AEP:NRC:2054

Donald C. Cook Nuclear Plant Unit 2
ADDITIONAL INFORMATION REQUESTED BY NUCLEAR
REGULATORY COMMISSION BULLETIN 2001-01
(TAC NOS. MB2624 and MB2625)

“D.C. Cook 2
Reactor Vessel Head Penetration Inspection
Final Report”

WDI-RVHP-002

Time of flight results for penetration #32 at 325 degrees are shown in the figure below:

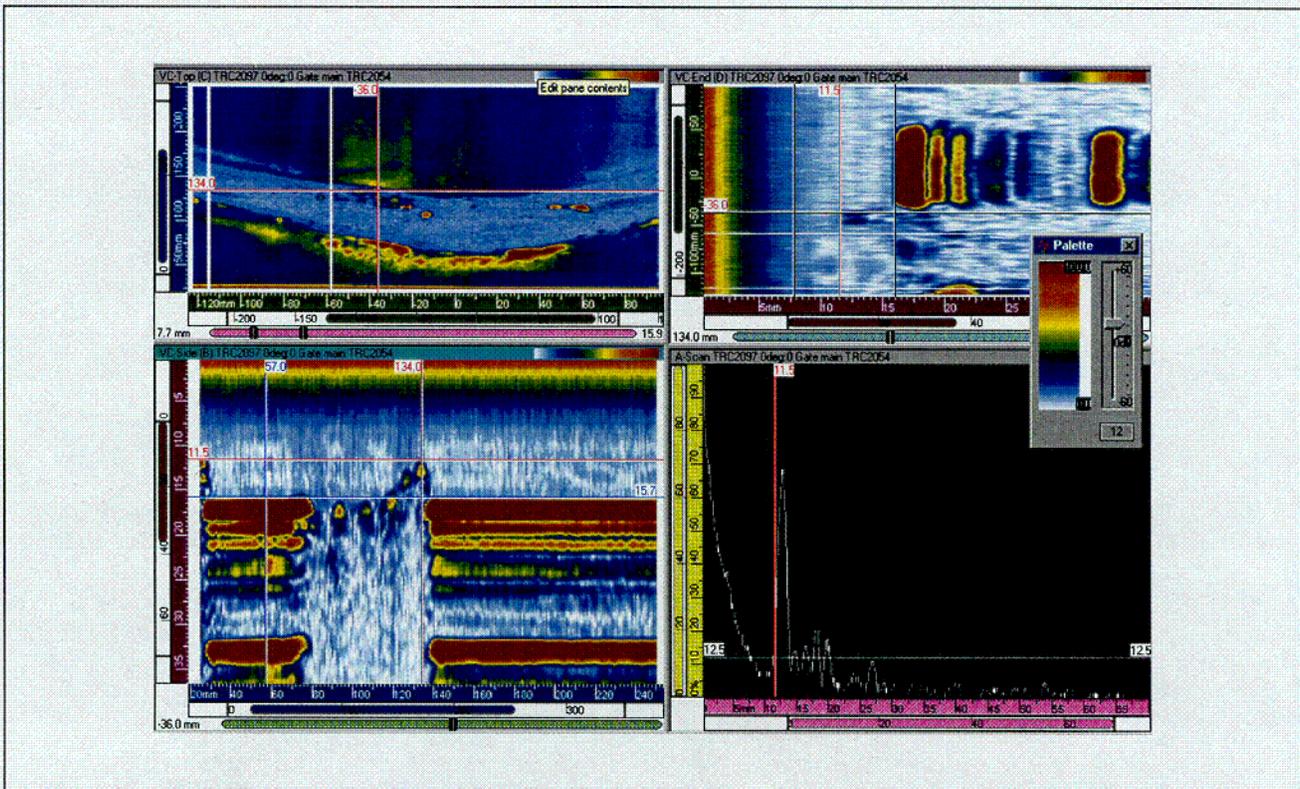
Observations regarding the TOFD results:

- The TOFD image shows 3 distinct reflectors at approximately 114, 120 and 127mm (4.48", 4.72" and 5.00") axial position which gradually increase from ~1mm to 4.2mm (~0.04" to 0.17") in depth from the backwall. The end view shows they have an extent of some 15°.
- The amplitude of the indication(s) is relatively high suggesting the source(s) to be volumetric in nature.
- Two other reflectors are apparent along the weld fusion line at lower axial elevations having similar characteristics.
- The TOFD results show the top of weld at the indication location is 132 mm (5.2 in.), 5.0mm (0.20") above the uppermost reflector. The reflectors are not above the weld.

Straight beam results for penetration #32 at 324 degrees are shown in the figure below:

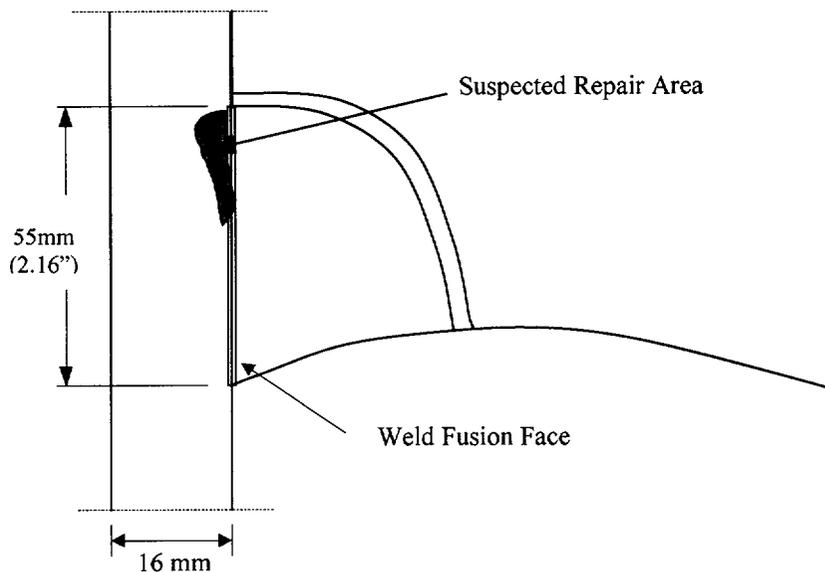
Observations regarding the straight beam results:

- The 0° image also shows 3 distinct indications above the interface that with correction for axial position from the recess appear to correspond almost exactly with those seen with TOFD. At this sensitivity level, we are unable to resolve responses from the bottoms of the 3 mm deep (0.12 in.) and 5.0 mm (0.20 in.) deep OD EDM notches in the calibration standard, indicating relatively large reflecting areas.
- The presence of these indications again suggest the source(s) to be more volumetric in nature.
- The two reflectors along the fusion line have similar characteristics in terms of amplitude and shape.
- The straight beam results show the top of weld at the indication location is 138 mm (5.4 in.), 4.0mm (0.16 in.) above the uppermost reflector. The reflectors are not above the weld.

These reflectors are more likely attributed to a possible repair area, with regions of incomplete fusion, rather than discreet planar reflectors with circumferential extent. This assessment is shown in the figure below:

This assessment of the nondestructive examination results, along with the eddy current and liquid penetrant examinations of the J-Groove weld of penetration #32, as well as the lack of any evidence of boric acid during the visual examination of the top of the head at any of the penetrations indicates the reflectors identified during TOFD examinations of the reactor vessel head penetrations at D.C. Cook Unit 2 are associated with the welding process and not service-related.
